# BOARD OF ZONING APPEALS STAFF REPORT

**Agenda Item:** BZA Docket No. 22-016

**Application Type:** **Developmental Standards Variance**

**Summary:** Munster Properties LLC requesting approval of a variance from *Table 26-6.4050-1* to allow a reduction in the required parking spaces for a medical office at 10350 Calumet Avenue.

Figure 2 New parking in 1<sup>st</sup> and 2<sup>nd</sup> lot layer circled in red is prohibited.

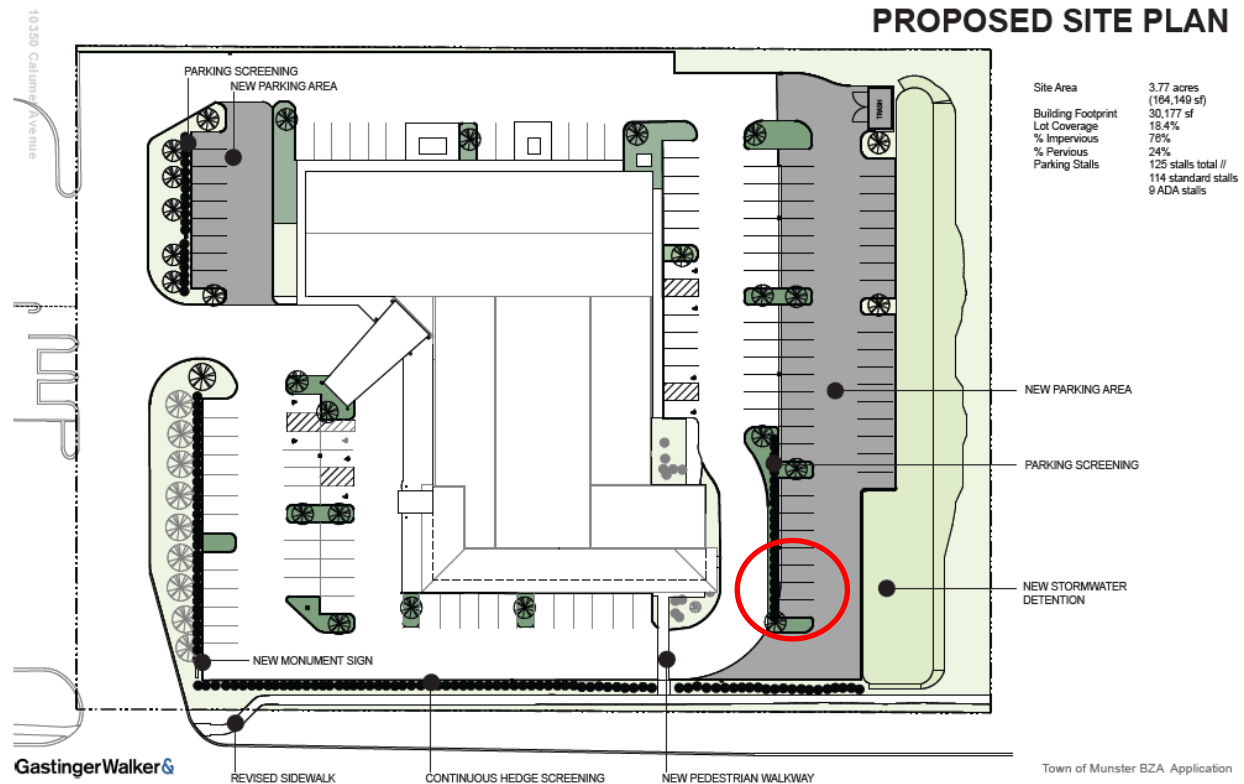
Staff notes that two of the proposed parking spaces are located in the first lot layer (the area between the front façade and the lot line) and two are located in the second lot layer (the first 20 feet of the side yard). While the existing parking in front of the building is permitted to remain, the Munster Zoning Ordinance prohibits new parking in the first lot layer and requires that all parking in the second lot layer be screened by an enhanced hedge. Eliminating these spaces will increase the requested variance by two to four spaces.
